RM230016 MANGAKURI SUBDIVISION – 402 MANGAKURI ROAD, MANGAKURI

A Transport Engineering Review (TER) dated 22 March 2023 was subsequently carried out by Stantec. This letter report has been prepared to address the questions raised by this review.

TRANSPORT ENGINEERING REVIEW

Figure 4 – Williams Road Northern Access North Approach

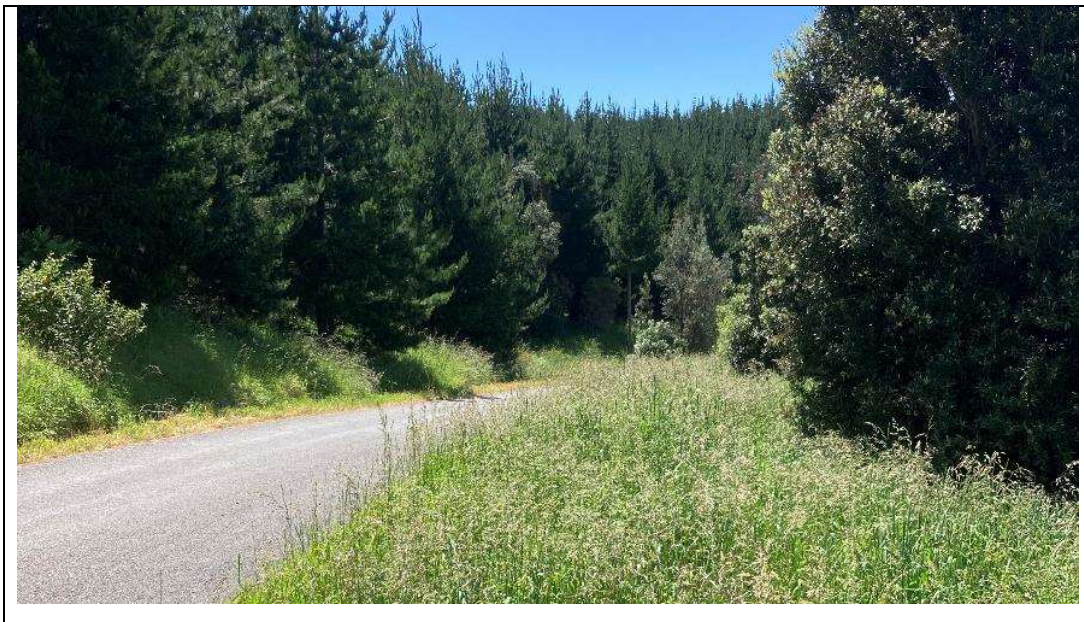
4. Applicant to provide an assessment of available sight distances against the PDP transport standard TRAN-S8.
5. Applicant to confirm extent of any earthworks necessary to meet sight distance requirements.

Austroads states that desirably sight distances at access should comply with the sight distance requirements for intersections. Accordingly, the sight distance requirements given in Section 4.1 of the TAR increase to 97m for a 50km/h speed environment.

As a result of the increased sight distance requirements four trees within the road reserve should be removed to the north of the northern access as shown in Figure 4.

Once these trees are removed, 97m of sight distance can be achieved in both directions from all accesses as shown in Figures 11 to 16 of the TAR. Regular berm mowing is still recommended to

Figure 5 – Okura Road Access Exit Gradient

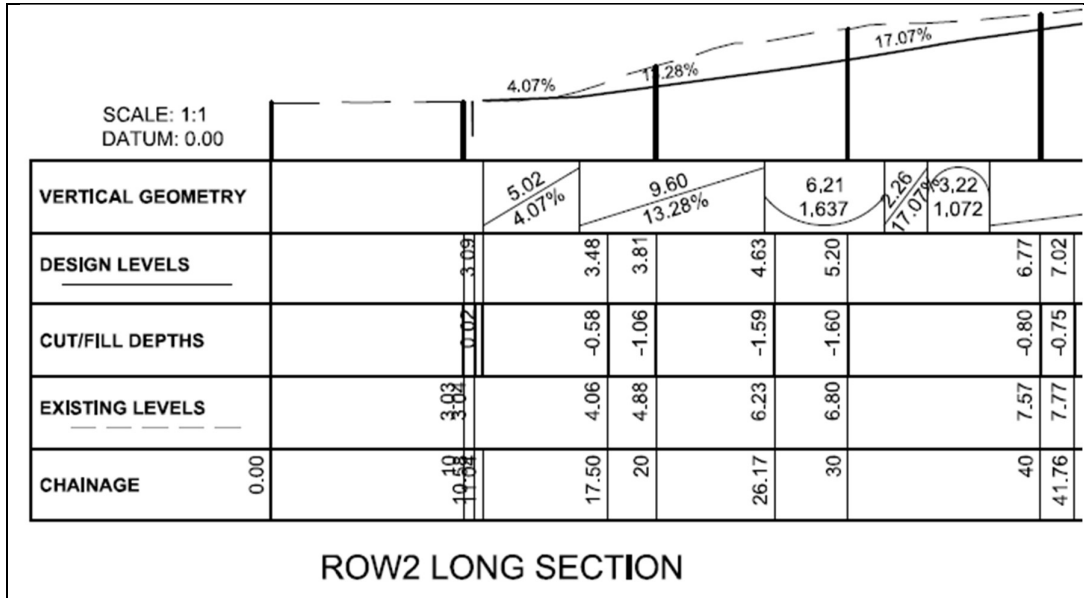
6. Applicant to confirm that a 5 metre long approach platform with a gradient of less than 5 percent will be provided on each right of way where they meet the frontage road.

The Figures below have been extracted from the Strata Group Limited plans to demonstrate the accessway gradients include a platform as recommended in the TAR.

Figure 8 – Okura Road Access Vehicle Tracking

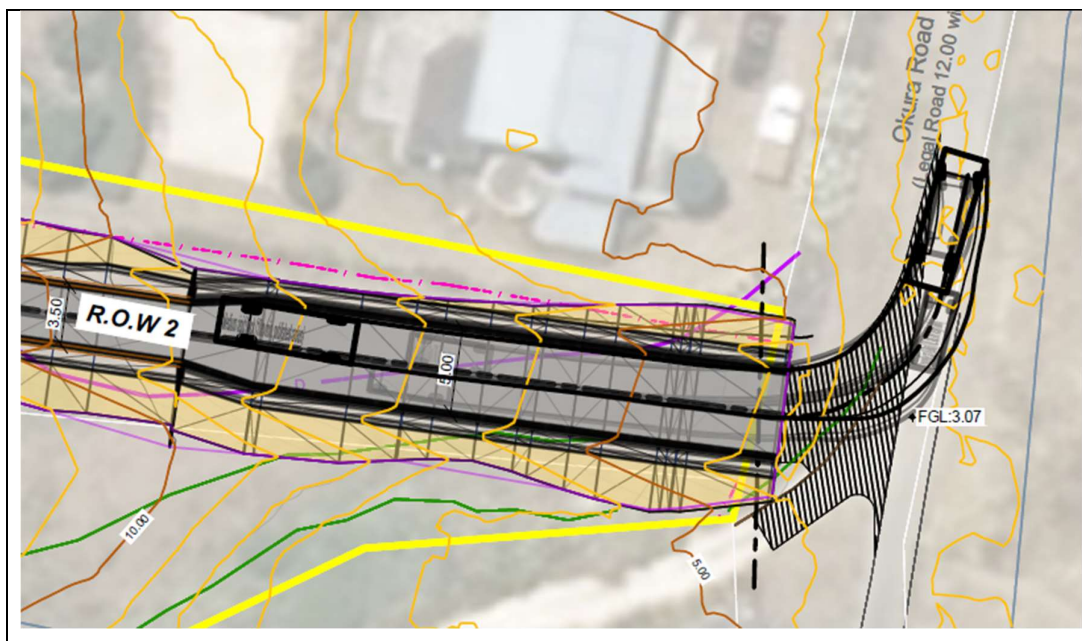
8. Applicant to update the ROW2 / Okura Road crossing design so that a medium length truck can turn without leaving the carriageway.

Figure 8 has been extracted from the Strata Group Limited plans to demonstrate the accessway provisions are suitably dimensioned as recommended by the TAR. The access is 5m wide over approximately 50m to ensure sufficient space for vehicles to manoeuvre past each other. No widening is recommended along the beach side of Okura Road. Medium rigid trucks (MRTs²) are only expected to access the site during construction or if a large fire appliance is called, in this case the vehicle body may overhang the edge of seal but wheels are expected to remain on the sealed surface.

Figure 10 – Williams Road Southern Access Vehicle Tracking

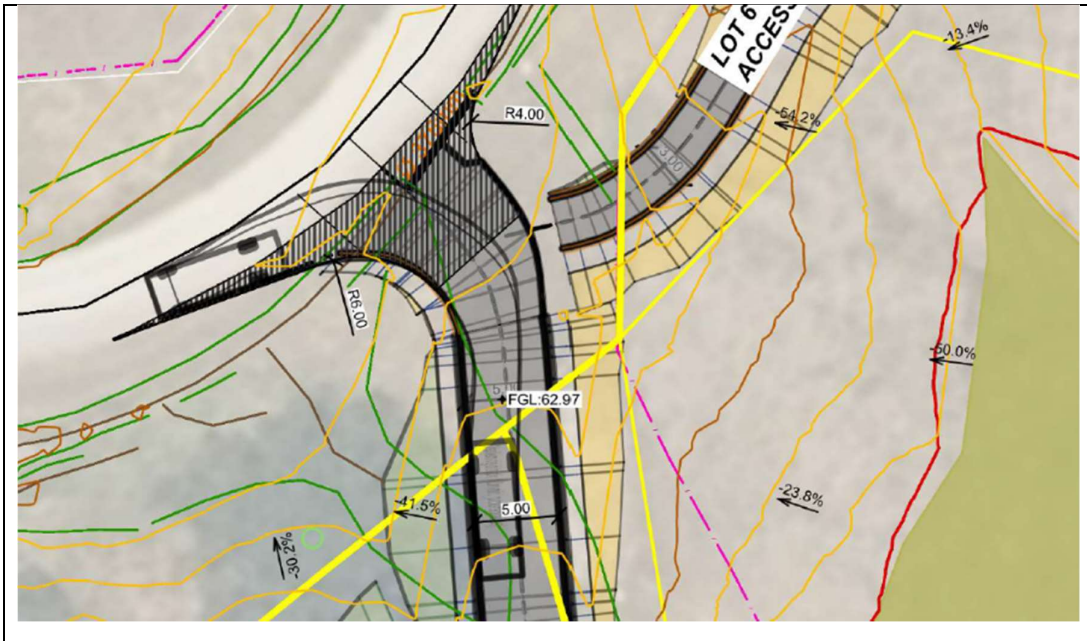
9. Applicant to update all vehicle tracking and confirm that the carriageway widths are sufficient to accommodate a medium length rigid truck.

The Figures below have been extracted from the Strata Group Limited plans to demonstrate the accessway provisions are suitably dimensioned as suggested in the TAR. Vehicle tracking has been checked using a MRT and the accessway is 5m wide over at least 25m to provide a passing opportunity at the ROW entry/exit and avoid queuing onto Williams Road.

The proposed designs are expected to exceed the relevant ODP minimums for residential activities but may not meet the CHBDC standard for rural residential properties. No stock truck or other heavy vehicle servicing is anticipated via any ROW, therefore this non-compliance is assessed as technical only and the accesses are expected to appropriately accommodate the proposed activities, with no adverse operational or safety effects on public roads.
